Re. : Amendment and Response to Office Action Mailed September 16, 2005
Appl. No. : 10/668,747
Filed : September 23, 2003

IV. REMARKS

Fig. 2

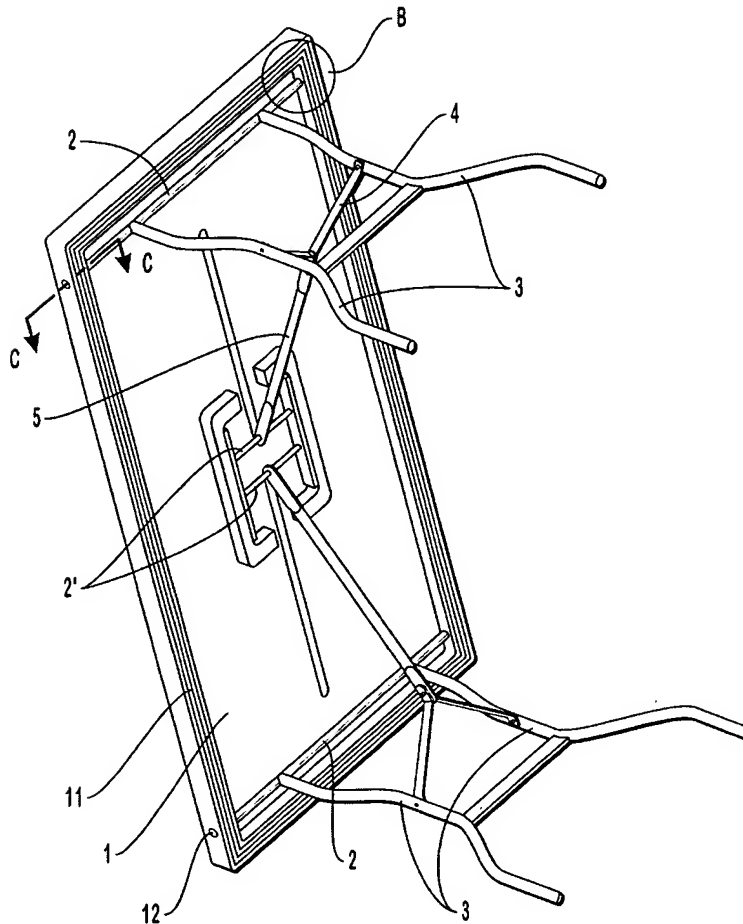
The Office Action objected to the drawings. In particular, the Office Action stated that Figure 1 should be designated by a legend such as --Prior Art--because only that which is old is illustrated. See MPEP § 608.02(g). The Office Action stated that the drawings are objected to as failing to comply with 37 CFR 1.84(p)(5) because they do not include the following reference sign(s) mentioned in the description: 22. The Office Action stated that the drawings are also objected to as failing to comply to 37 CFR 1.84(p)(5) because they include the following reference character(s) not mentioned in the description: B-3, B-4, and 2’.

As set forth above, Applicants amended the specification to conform the specification to Figure 2. In particular, Figure 2 illustrates that a center bar 2’ may be connected to a bar 5 and that the bar 5 may be connected to a strut 4:

Accordingly, Applicants amended paragraph [055] of the specification by replacing the reference 22 with the reference 2' to conform the specification to Figure 2:

Consequently, the description now properly includes the reference 2' and no longer includes the reference 22.

Fig. 5

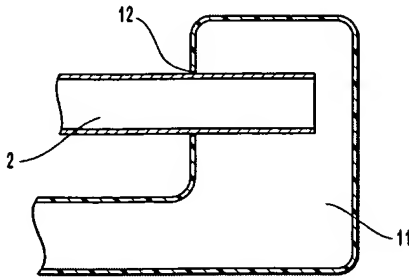
Figure 5 illustrates a cross pole 2 disposed in an aperture 12:

Fig. 4

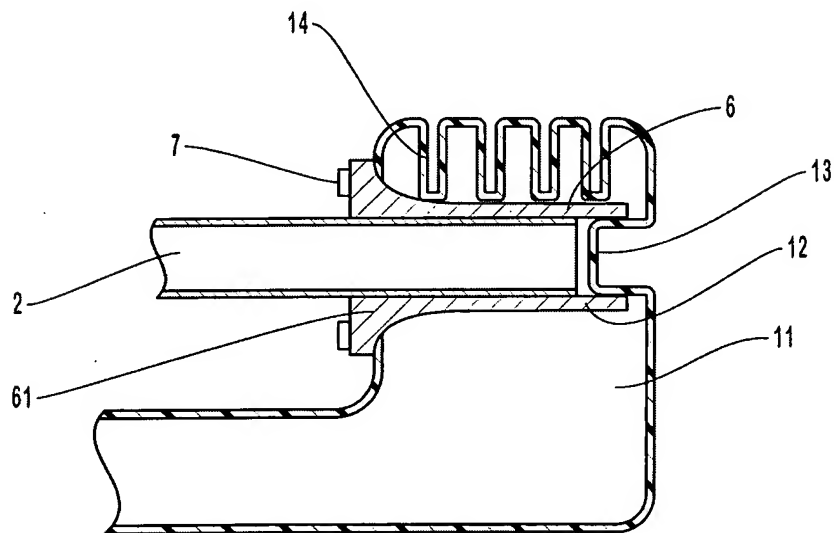
Figure 4 illustrates a plurality of grooves 14:

Fig. 2

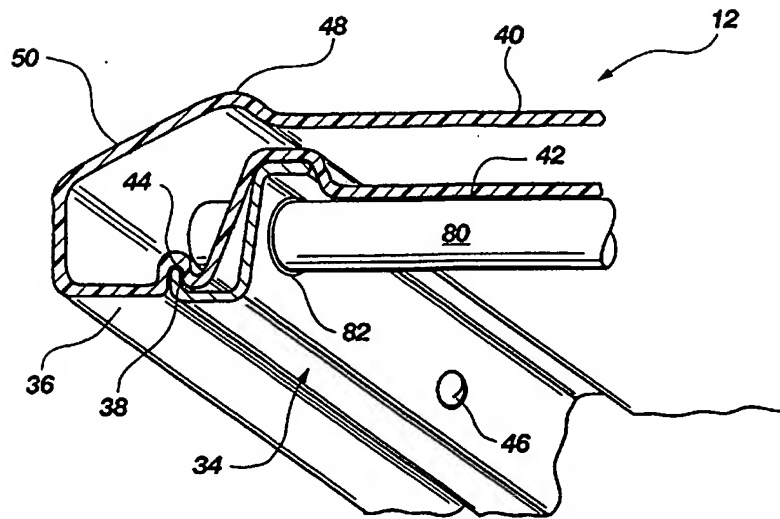
In contrast, the Nye Patent discloses that an edge of a side rail fits in a notch. For example, Figure 2 illustrates an edge of a side rail of the table top frame 34 that fits in a notch 44:

However, the Nye patent does not disclose a plurality of notches 44, 64 that abut the same end of a cross pole. Moreover, it would not be obvious to modify the Nye patent to include a plurality of notches that abut the same end of a cross pole. As mentioned above, the Nye patent's notches are intended to receive an edge of a side rail. After a first notch received the edge of the side rail, an additional notch would have nothing to receive and, thus, would have no purpose. One skilled in the art would have no motivation (i.e., no purpose) for adding an additional notch.³ Further, even assuming for the sake of argument that an additional notch were added, one skilled in the art would not have any motivation to position the additional notch to abut the same end of the cross pole that a first notch abutted.

Fig. 2A

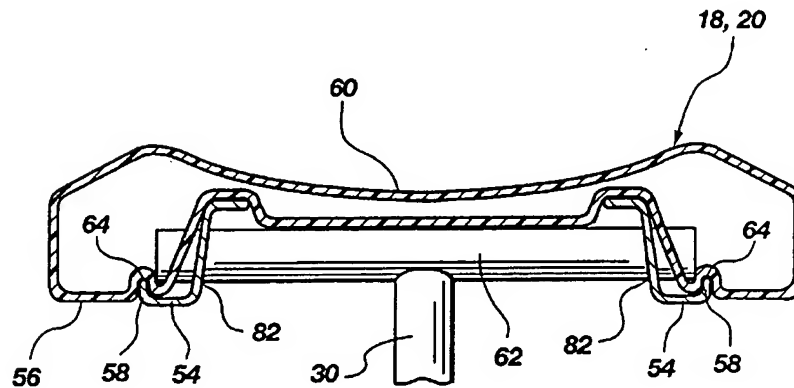
The Office Action rejected Claims 1, 3, 4, 8, 14, 16, 18 and 19 under 35 U.S.C. § 102(b) as being anticipated by U.S. Patent No. 5,921,623 issued to Nye et al. In particular, the Office Action stated that the Nye patent teaches a table (Fig. 2A) comprising: a plastic blow molded table top (12) having a lip (see depending portion of 12 in Fig. 2A and Attachment A) with interior, outer and bottom surfaces and a first connecting aperture (82) located in the interior surface; a first table leg (30); and a first cross pole (62) attached to a first end of the table leg and disposed in the first connecting aperture. The Office Action states that the lip also includes a groove/recess (64). The Office action states that, since the Nye patent teaches all of the structural limitations found in the method claims, the method steps would be inherently provided for.

In addition, as shown in Figure 3, an edge of a side rail of the bench frame 54 fits in a notch 64:

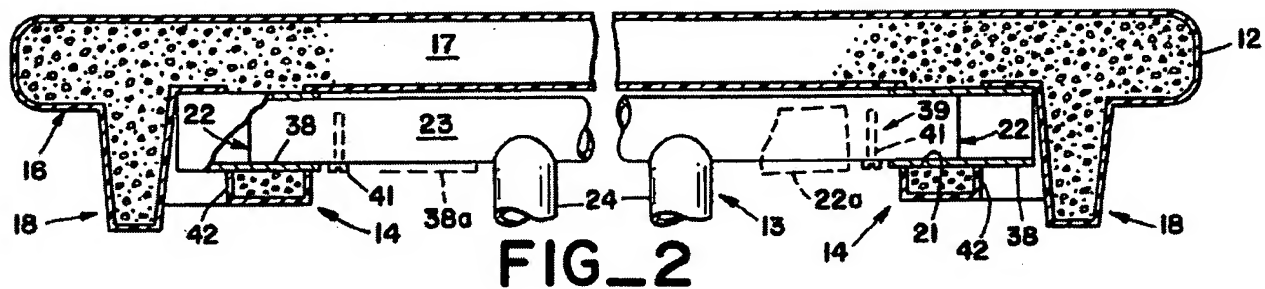
While the Nye patent does not disclose a plurality of notches that abut the same end of a cross pole, the Dutro patent does not disclose even one such notch:

Moreover, Applicants respectfully submit that the Dutro patent teaches away from the proposed modification. In particular, the Dutro patent teaches away from the use of a fixing plate (as recited in Claim 7) by emphasizing the use of threaded screws 41 to limit the movement of the bushings 38 relative to the "member 23":

Figure 1
(Prior Art)

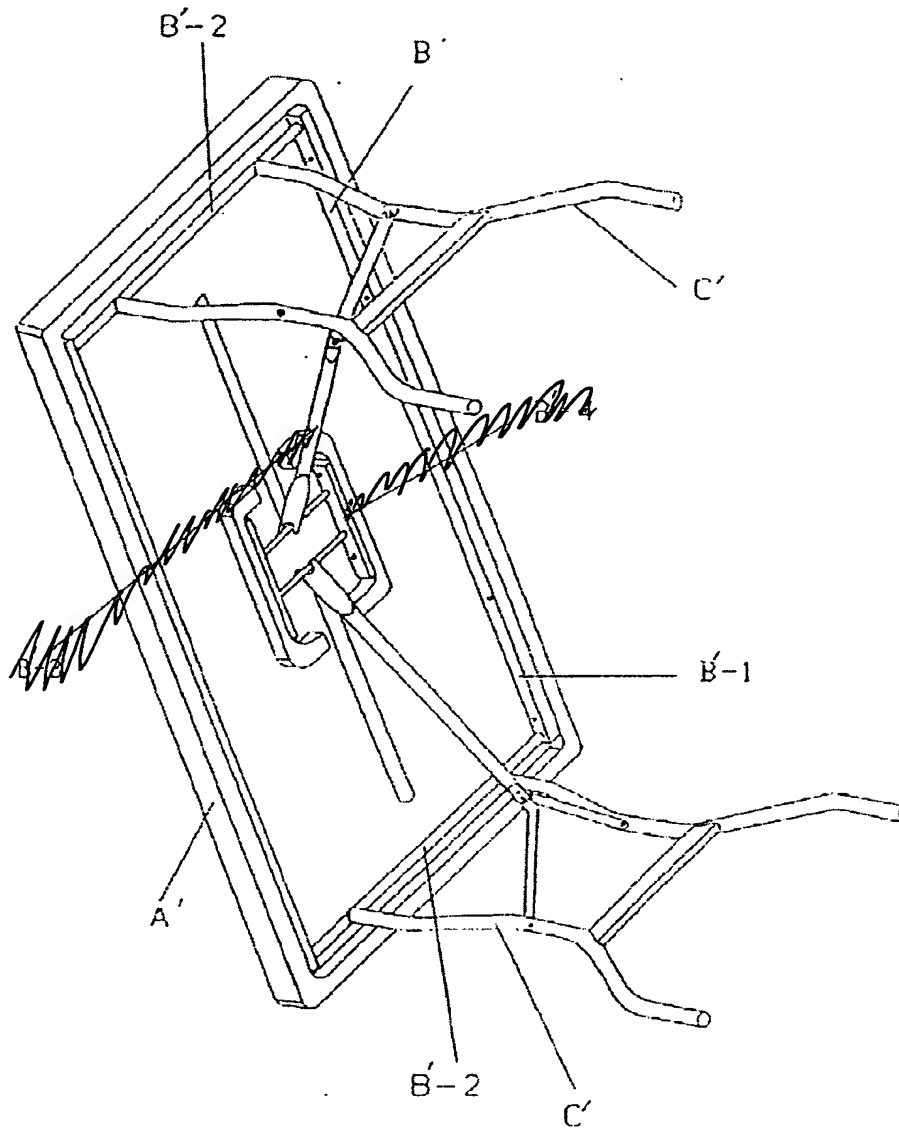
The attached replacement sheets of drawings are formal drawings to replace the drawings originally filed. The attached replacement sheets of drawings also include an amendment to Figure 1 that adds the legend "PRIOR ART" to Figure 1 and removes references B'-3 and B'-4. These attached replacement sheets of drawings, which include Figures 1-6, replace the original sheets of drawings which included Figures 1-6.

An annotated or marked-up sheet of drawings for Figure 1 is also attached. The annotated sheet of drawings shows the proposed drawing corrections in red ink.

As set forth above, Applicants amended Figure 1 to include the “Prior Art” legend and therefore request that the objection based upon the omission of the “Prior Art” from the drawings be withdrawn.

Applicants amended Figure 1 to remove the references B’-3, B’-4 and therefore request that the objections based upon the inclusion of the references B’-3, B’-4 in the drawings be withdrawn.
